REDIFON LTD
LONDON

TITLE R50 RECEIVER – BLUE SPOT

WD1/2719/L

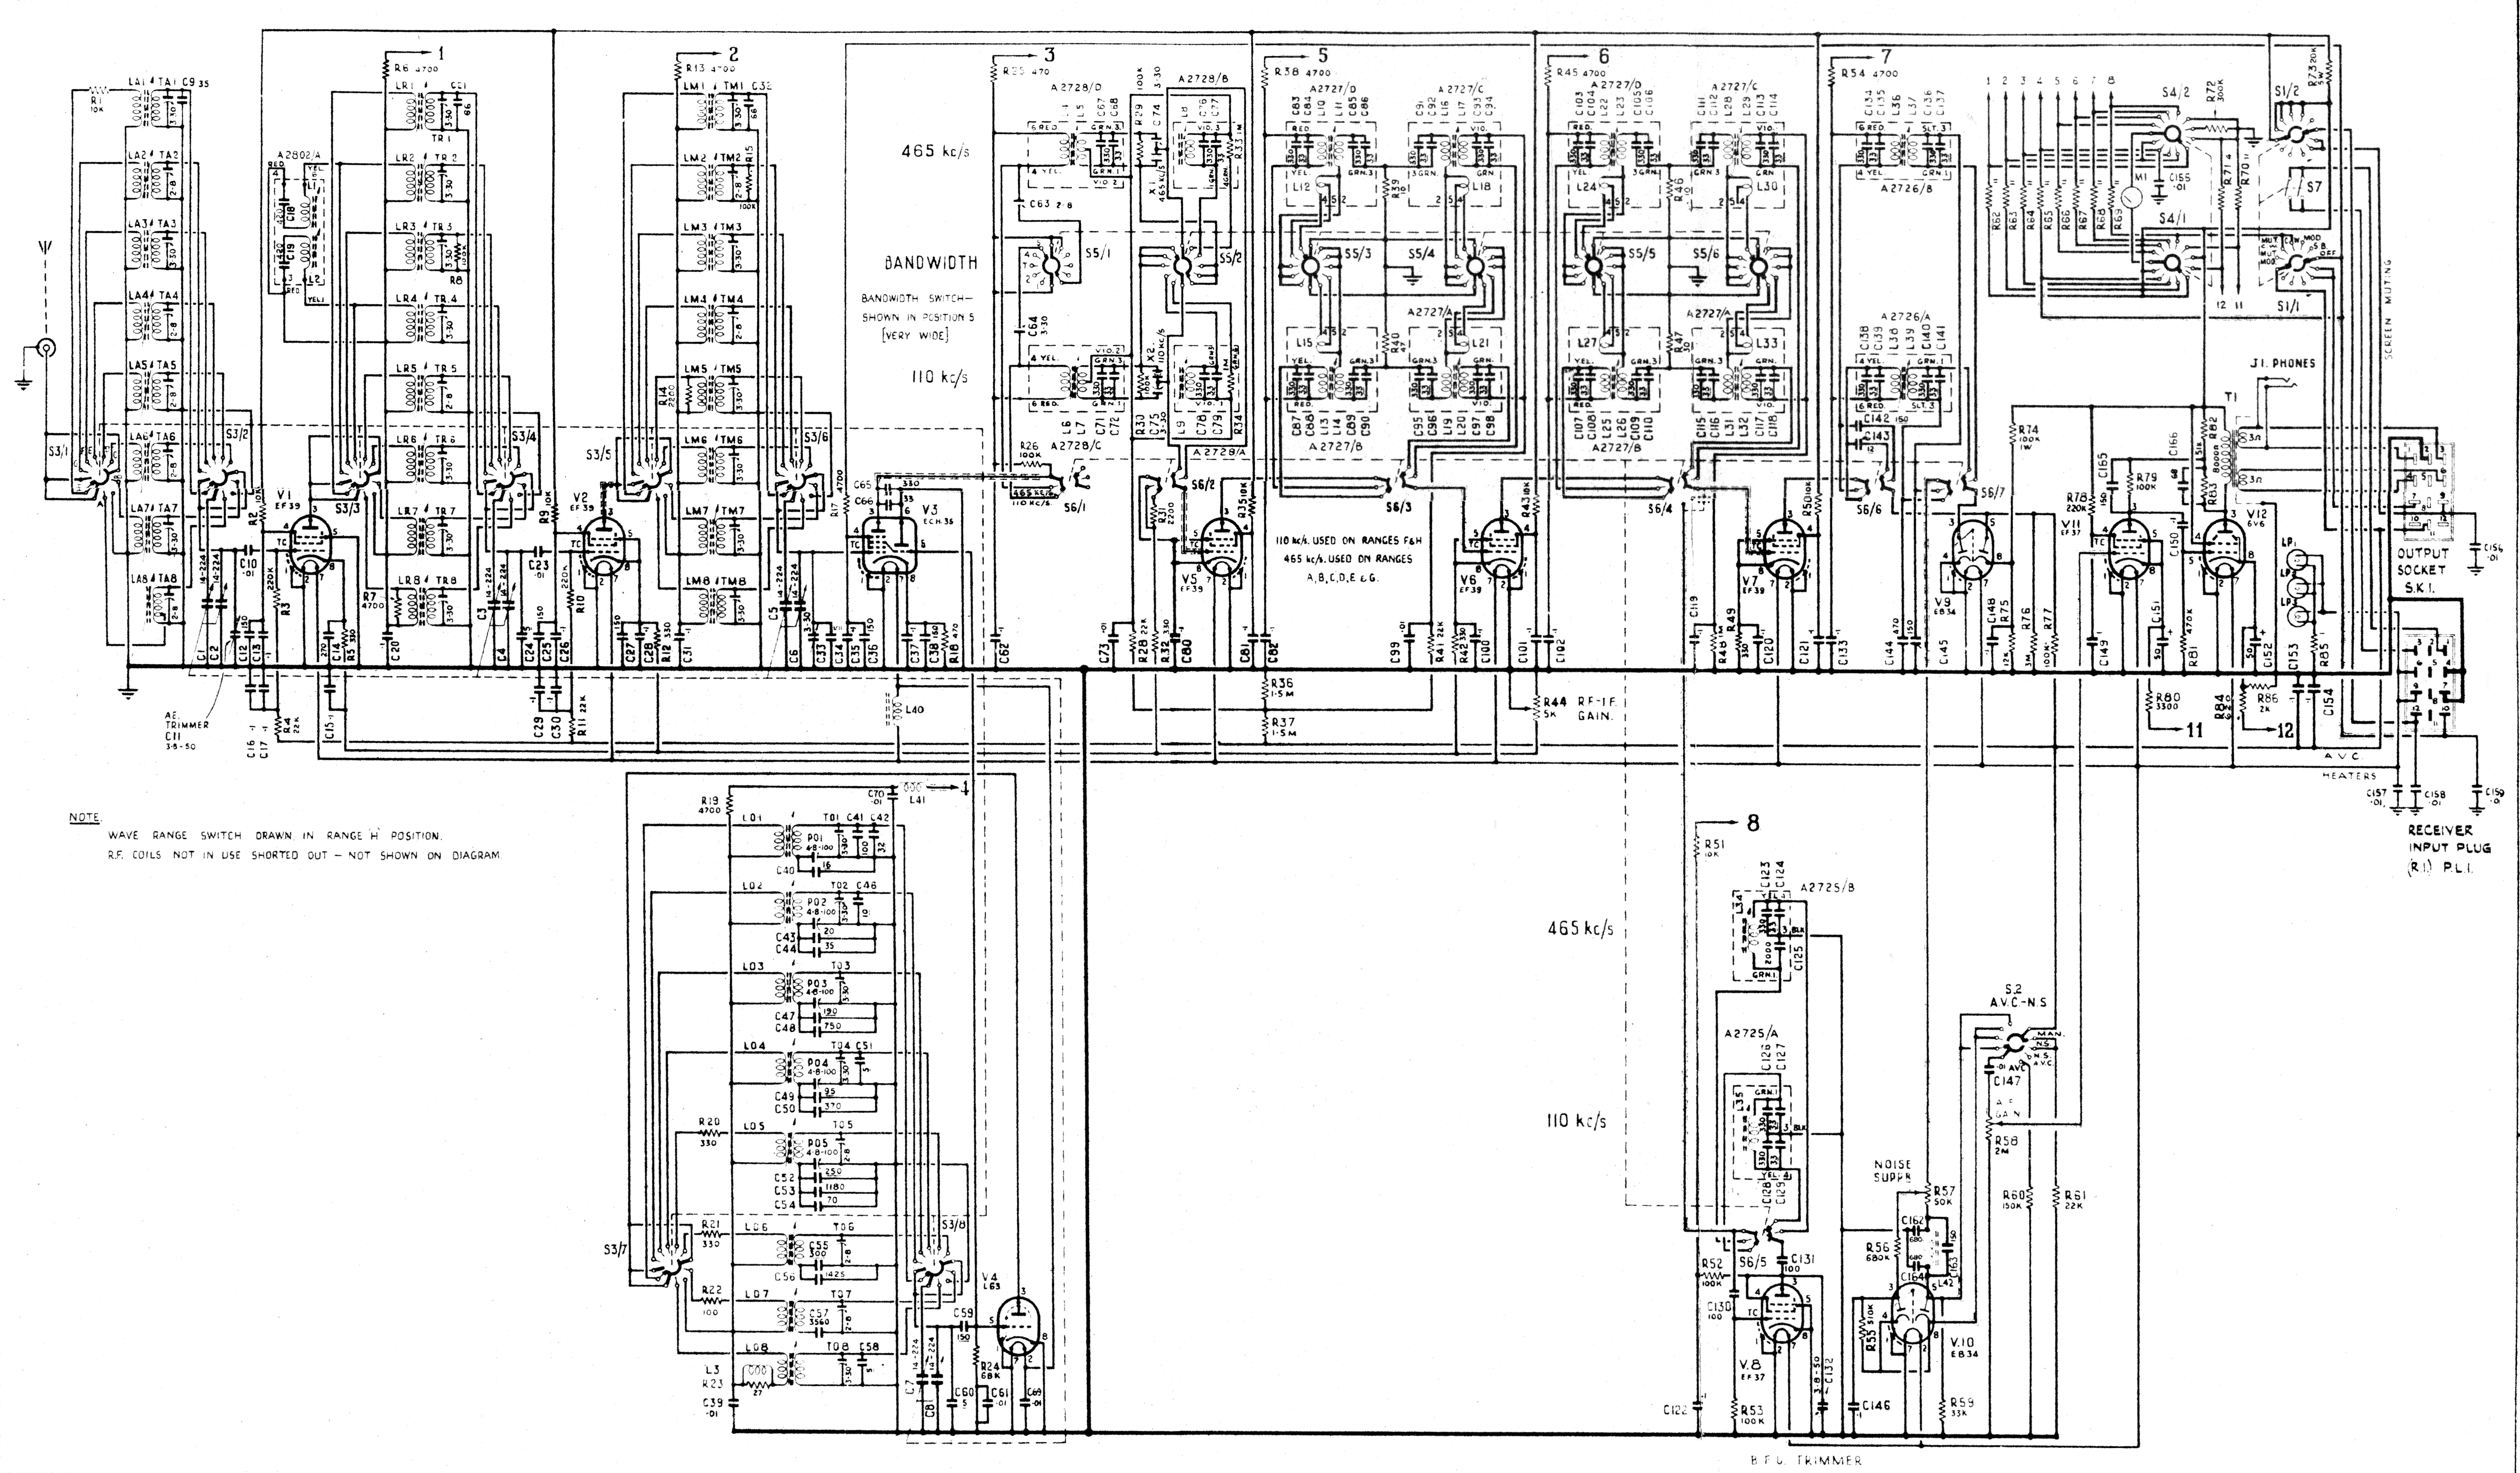
ISSUE
1. 9. 8. 48.
R27 DELETED.
C30 WAS ·1µF.
C65/66/69/70 R36 REPOSITIONED.
L40/41 C155/156/157/158 C159 ADDED.
SCREENING ADDED TO LEAD PL1 PIN 10
CH/N 4609/L
2. 10 3 49
C22 (IN PARALLEL WITH TR8) DELETED.
CH/N. 4694/L.
3. 22. 4. 49.
CIRCUIT MODIFIED TO SUIT BLUE SPOT RECEIVER.
CH/N. 4958/L.
4. 17. 11. 49
PLUG AND SOCKET RENAMED
5. 19-1-50.
R1G (ACROSS TM5) DELETED.
CH/N. 5137/L
6. 14. 4. 50.
